CCI Response to Pre-exhibition Comments

Cooks Cove Planning Proposal Gateway Determination (2022-1748) Response to TfNSW Preliminary Pre-Exhibition Comments

Table 1 – Cook Cove Inlet response to TfNSW comments and suggestions

Figure 19 Intersection design – Marsh Street / Gertrude Street

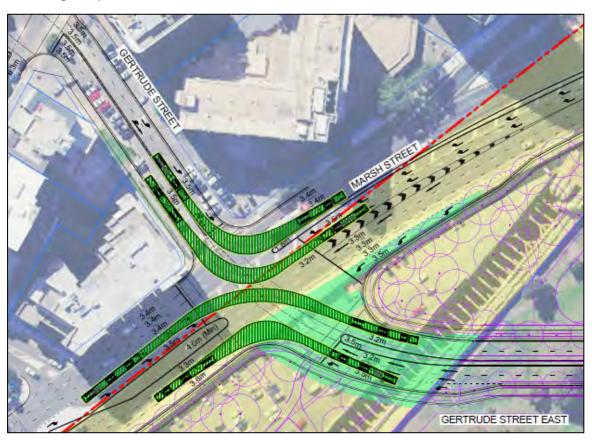
Item	Section/page reference	TfNSW comment/suggestion 17/02/23	CCI Response 02/03/23
25	Appendix E	 Marsh Street & Gertrude Street traffic signal design: It appears all stop lines are set back significantly from the intersection itself. This will have a significant impact on both traffic signal efficiency and safety. The intersection loss time due to increased inter-green periods for all phases will impact on traffic signal performance. In addition to the above, motorists turning left from all approaches will have limited sighting of pedestrians due to set back stop lines, which would impact on pedestrian safety. To mitigate safety concerns the traffic signal operation will need to implement full pedestrian protection for these approaches. This would result in left turn red arrows being displayed for traffic turning left from both Gertrude Street and the Gertrude Street East approach for 30-34 seconds. In practical terms this would result in the left turn red arrows being display for virtually the entire phase time allocated to through traffic in Gertrude Street and Gertrude Street East. Have signalised slip lanes been considered for the left turn movements from Marsh Street into Gertrude Street East and from Gertrude Street East into Marsh Street. If not they should to improve intersection efficiency by reducing pedestrian crossing lengths and improve pedestrian safety and limit impacts to the Airport and M5/M8 motorway. A pedestrian crossing exemption would be required for the pedestrian crossing across Marsh Street east. The report should include data to support and justify this. Provisions should be made in signal hardware etc., for future installation of a signalised pedestrian crossing if required. Concern remains regarding the alignment of the proposed signalised pedestrian crossing of Gertrude Street (East) as shown below: 	The design of the Marsh Street and Gertrude Street intersection has been updated by Arup in response to TfNSW commentary please refer Attachment B. The stop lines have been moved closer to the intersection to address concerns raised about the efficiency of the signal's operation, improve pedestrian safety with improved sight lines and provide better connection for shared path users. In addition, staggered crossing can be provided on Marsh Street.

These design amendments are intended to address concerns raised about the efficiency of the signal's operation, improve pedestrian safety with improved sight lines and provide better connection for shared path users. In addition, staggered crossing can be provided on Marsh Street.

PROPOSED COOK COVE MC01 SITE ACCESS

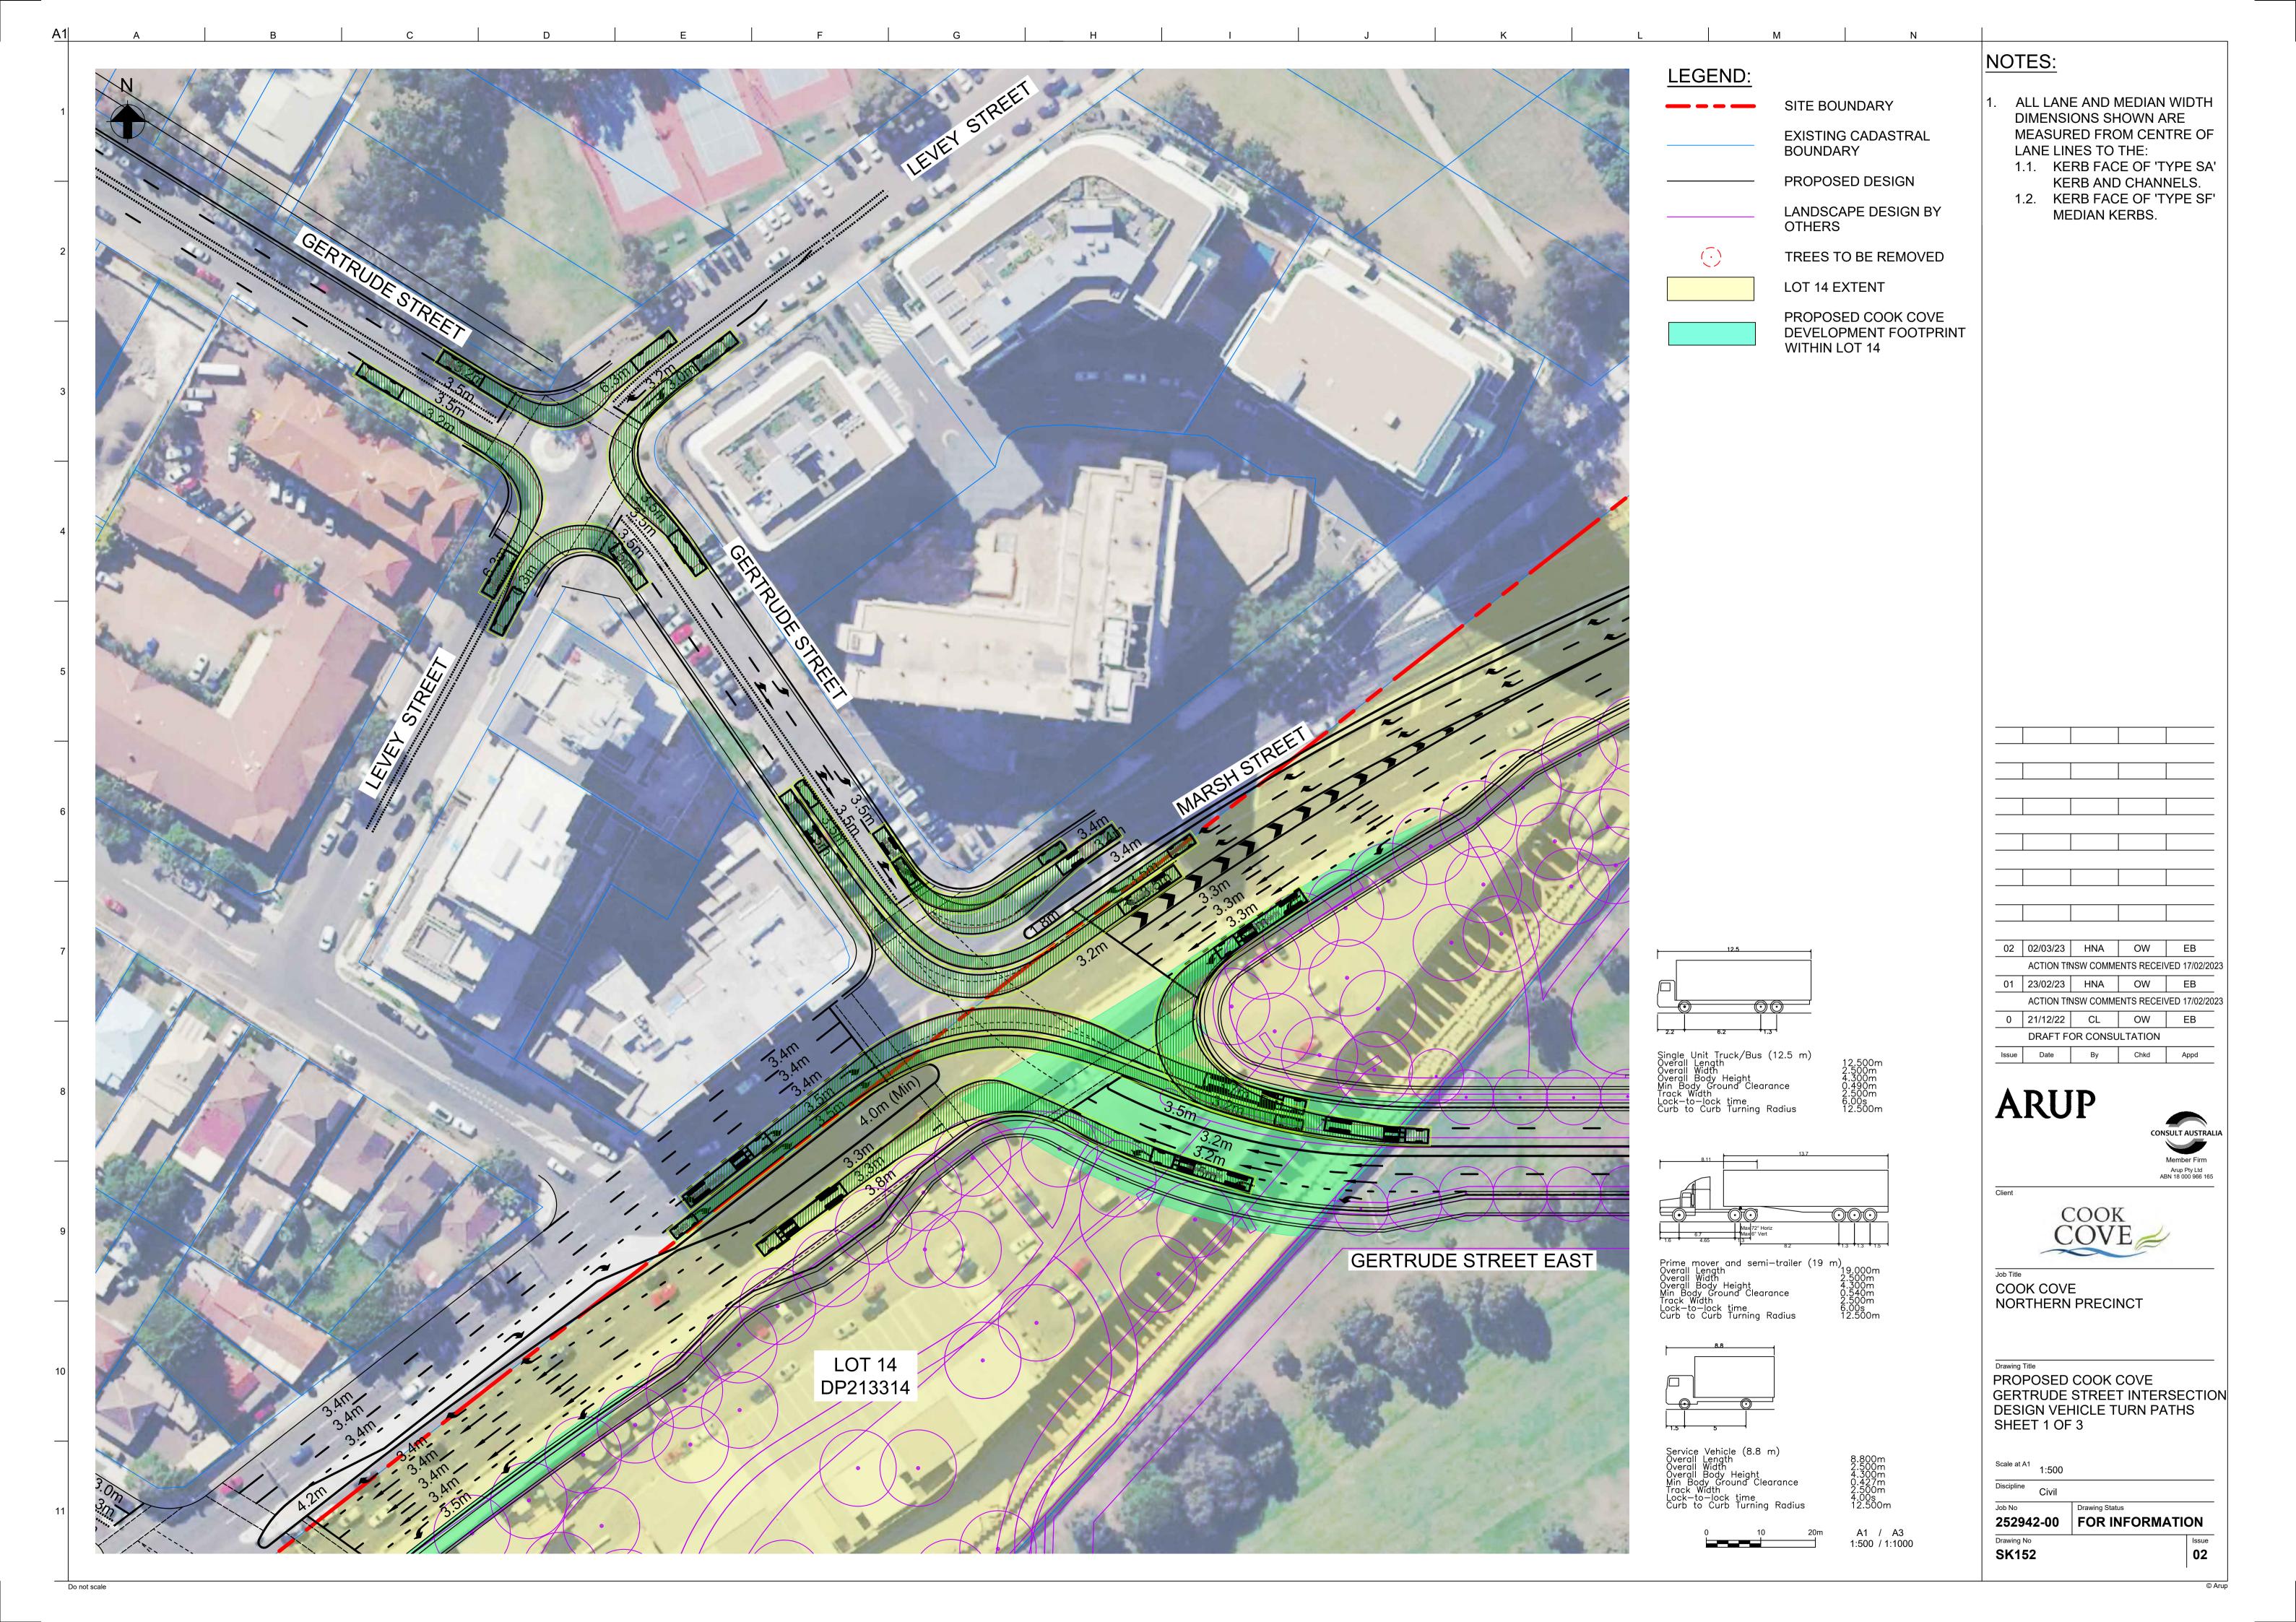
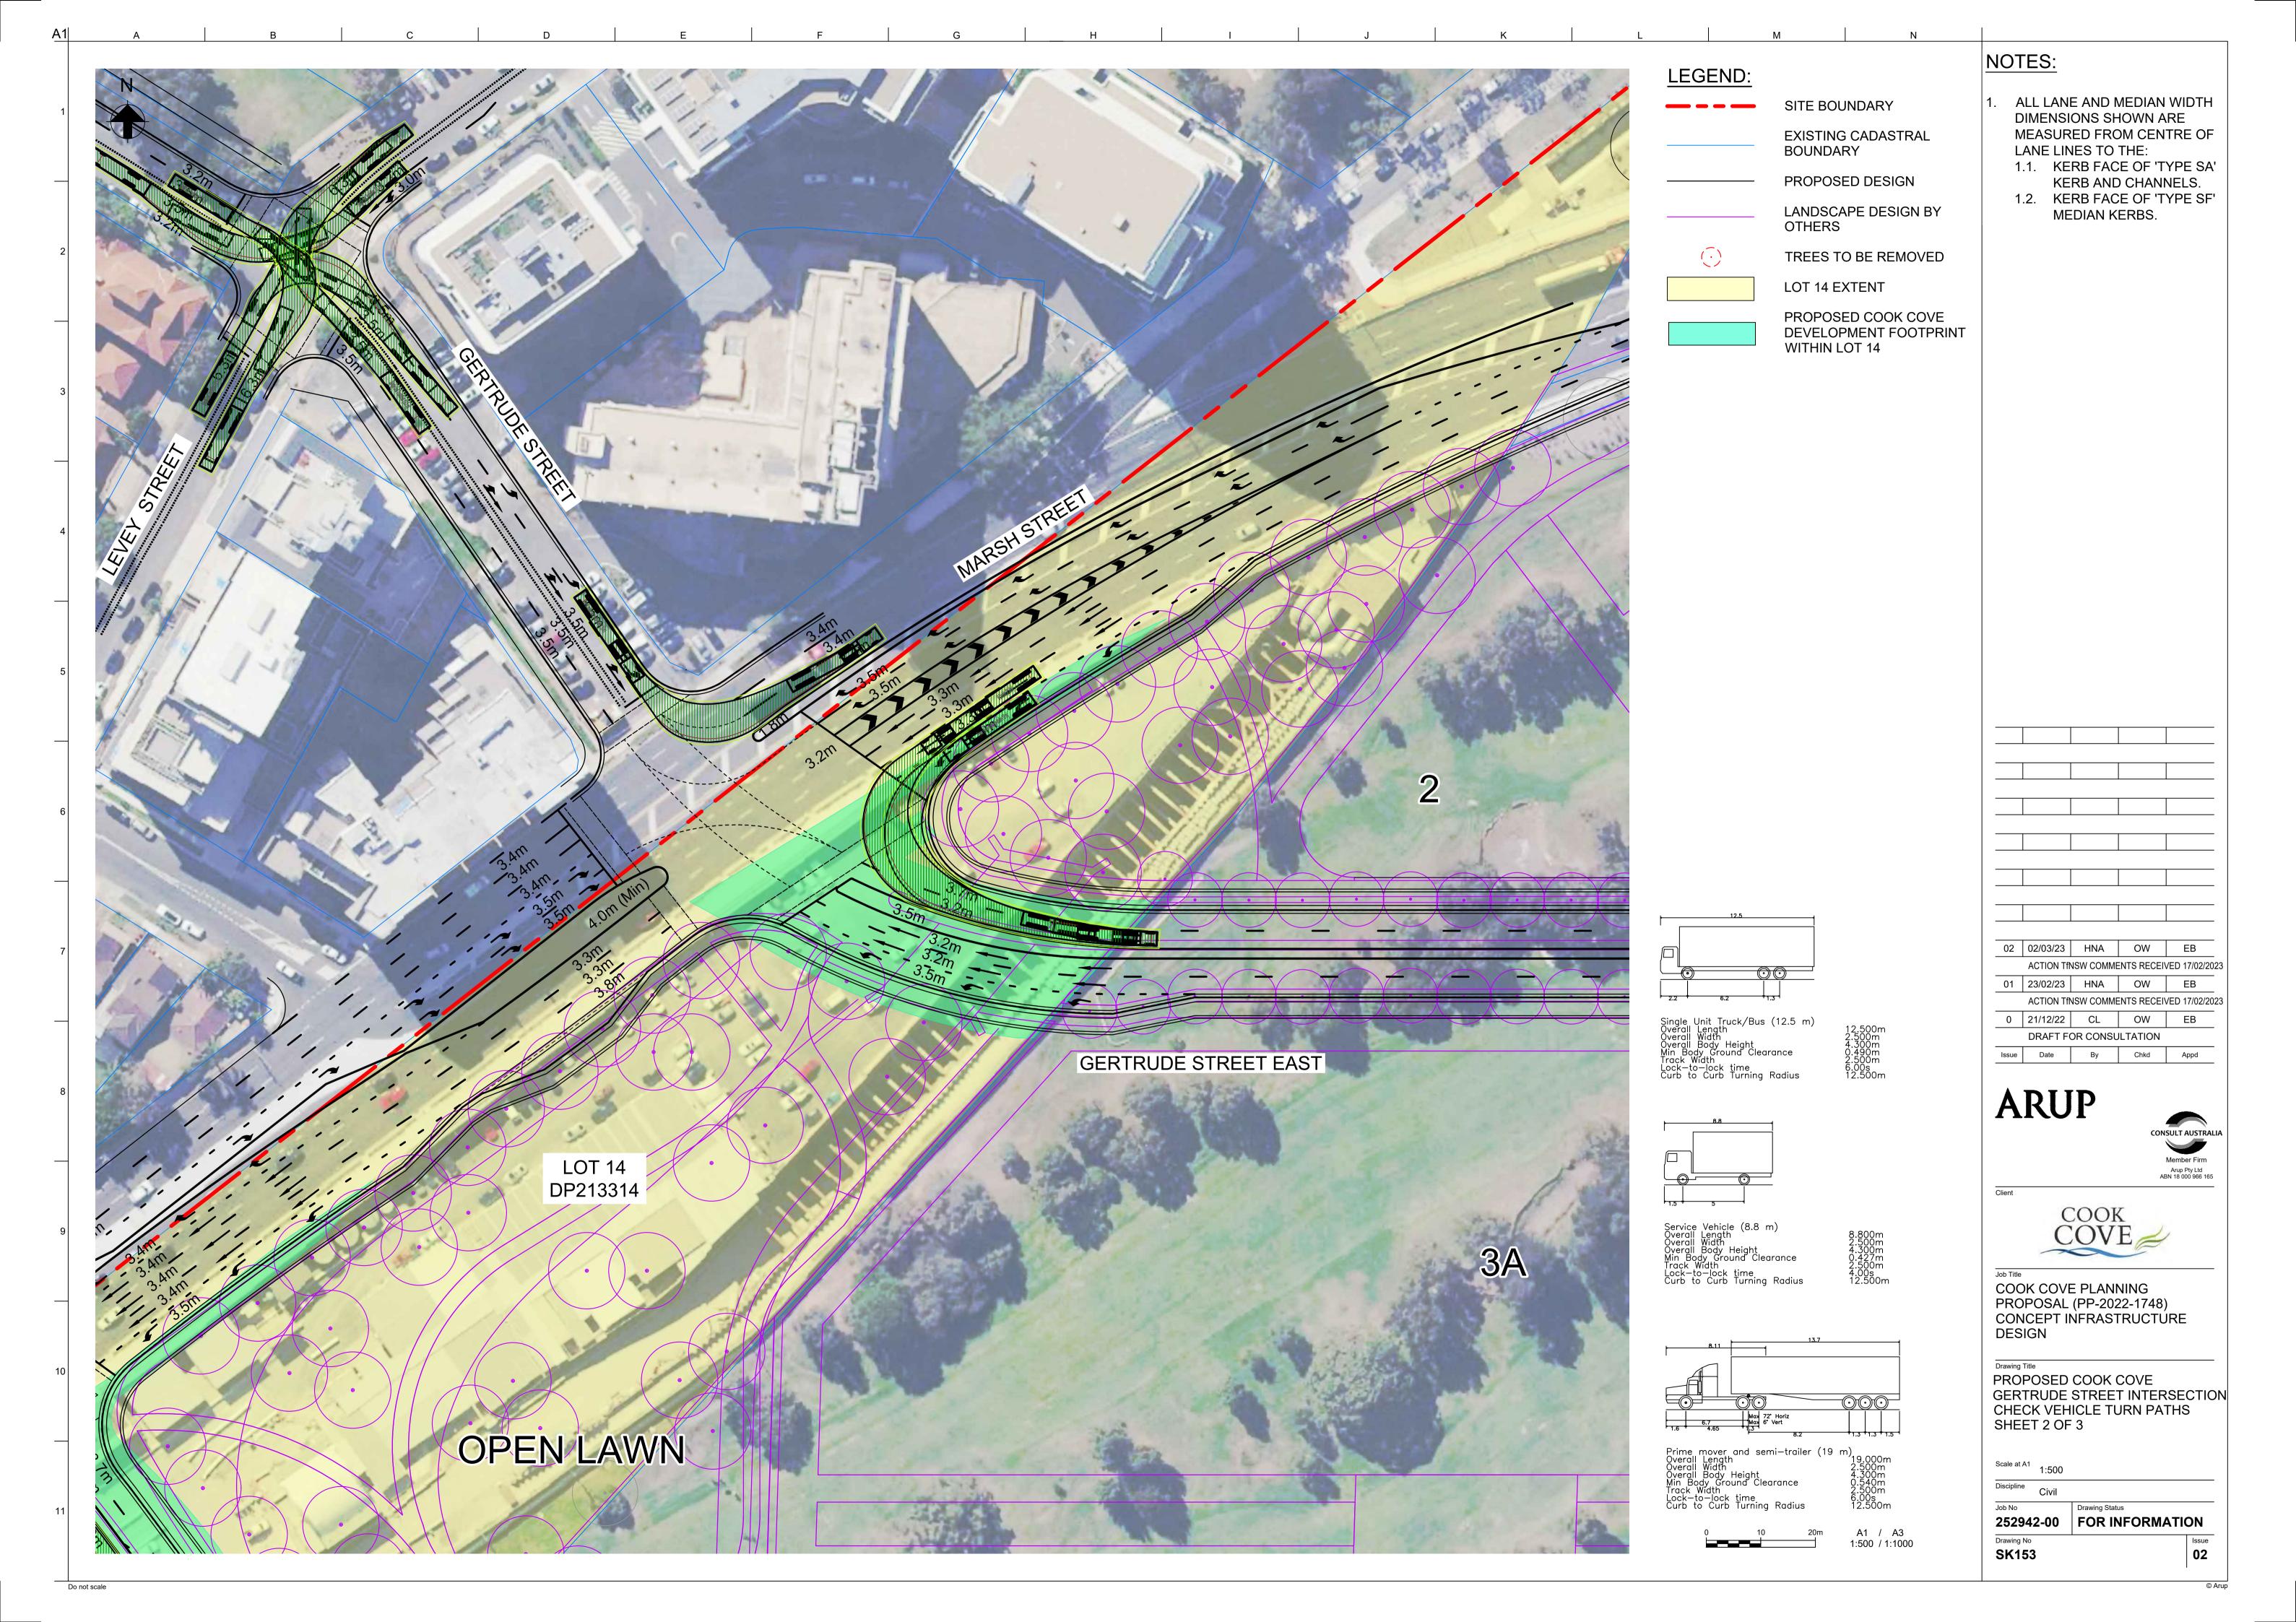
27	SK109	MC01 Site Access road shows lane widths of 2.0m. It is assumed that this is a typographical error. This should be clarified.	This was a typographical error. The access road lane width is 4m wide (kerb invert to centre line). This is corrected in the amended sketch SK109, refer Attachment B .
28	SK109	No right turn paths are supplied for the Flora Street existing right turn and through lane arrangement.	This is acknowledged. These swept paths have been amended and the sketches updated, refer to SK158 in Attachment B .
29	SK109	On plan SK019 Gertrude Street East has two through lanes and a left turn lane however plan SK152 shows vehicles turning right. TfNSW understands this may be included in error as it is no longer proposed to have right turn out of the site at this location in the modelling. Please clarify.	TfNSW understanding is correct. This was an error. The swept path has been removed. SK152 has been updated to show the correct swept paths, refer Attachment B .

OPTION 4: TfNSW works + trimmed mound + trimmed Cooks Cove

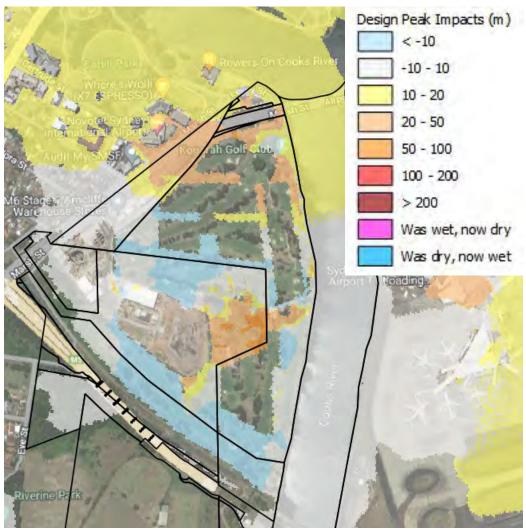
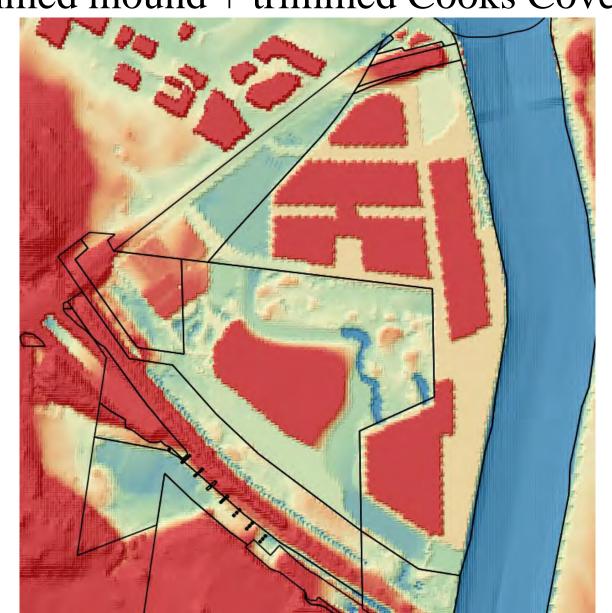
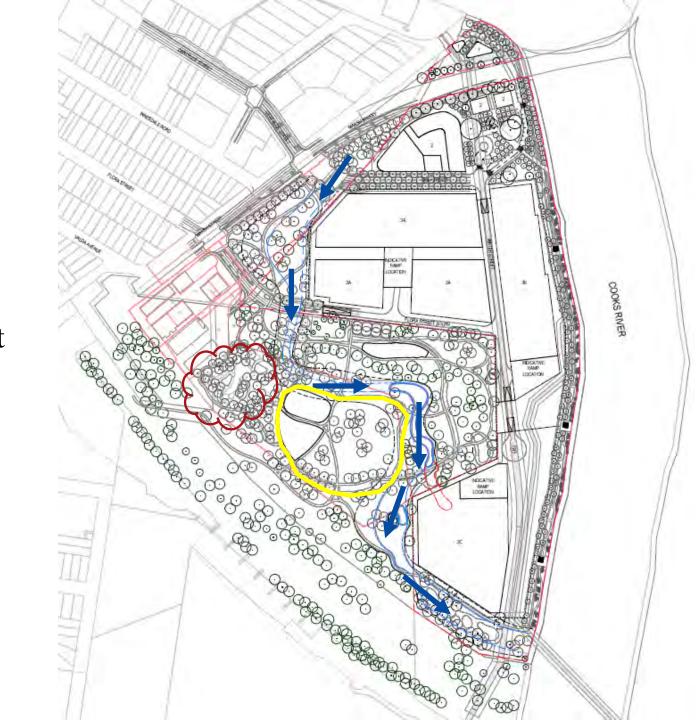
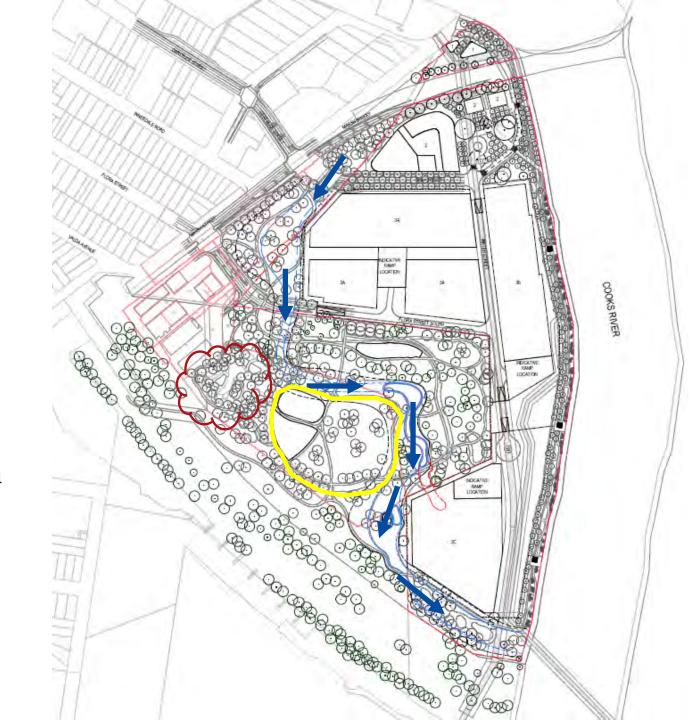
2	General	TfNSW requests that the Cooks Cove planning proposal documentation identifies the infrastructure already being provided by TfNSW through the M6 Stage 1 Project under approval including the location of the carpark and pump track, and identifies the intention to cooperate in resolving conflicts without incurring additional cost to the M6 Stage 1 Project. The flooding analysis, design and performance must recognise the existence of M6 Stage 1 compliant infrastructure levels. The M6 Stage 1 Project has substantially completed design of infrastructure to be located within the Arncliffe Construction Compound area in consultation with Bayside Council. Condition of Approval E154 of the M6 Stage 1 Project requires the project to prepare an Urban Design Landscape Plan (UDLP), in accordance with the project objectives, the commitments made in the EIS and submissions report, and the requirements of the approval. The M6 Stage 1 UDLP includes areas that are also shown within the provided 'Cooks Cove Development Precinct Masterplan' (the Masterplan). The Masterplan differs in the open space detail shown for these areas. The M6 Stage 1 UDLP is substantially complete and is currently on public exhibition. TfNSW requests the cooperation of the proponent in resolving any potential conflicts in these areas with the objective of doing so without incurring additional cost to the M6 Stage 1 Project.	The Proponent will at all times most willingly cooperate with TfNSW, the M6 Stage 1 Project team, Bayside Council and DPE to identify options to resolve potential design conflicts as cost efficiently as possible. We are not privy to the commercial terms agreed between the M6 Stage 1 project and it's contractors. The Cooks Cove Urban Design and Landscape Report, developed by Hassell in consultation with Bayside Council, can be updated to highlight design conflicts with the UDLP design for the Marsh Street Park. If TfNSW wishes us to proceed with this amendment, the project team will require drawings in dwg format of the proposed Lot 14 car park and pump track. The current location of the pump track conflicts with the future Gertrude Street East extension. Bayside Council have advised they do not support the present location of the UDLP car park or pump track. We request the Gertrude Street extension be allowed for, by locating the pump track scope in a location consolidated to the south. As per the Proponent's presentation provided by ARUP to the M6 Stage 1 team and Bayside Council (24/2/23) in relation to flood mitigation provisions, we do not believe the current TfNSW UDLP design is compliant with M8/M6 Conditions of Approval pertaining to Flood Mitigation. The preferred Cooks Cove flood option mitigation approach will permit compliance with M8 and M6 CoA and deliver superior access and open space outcomes for the community. The preferred option to be delivered by Cooks Cove recognises and maintains the required PMF resilience of the Arncliffe MOC and will achieve acceptable

- allows Cooks Cove to meet Gateway Determination conditions
- allows TfNSW to meet B23 condition
- is a better open space outcome for Bayside Council
- afflux for floods up to 1% AEP less than 10mm and also for PMF (at M6/M8)
- maintains low flood velocities in frog ponds
- is possibly cheaper without sports fields
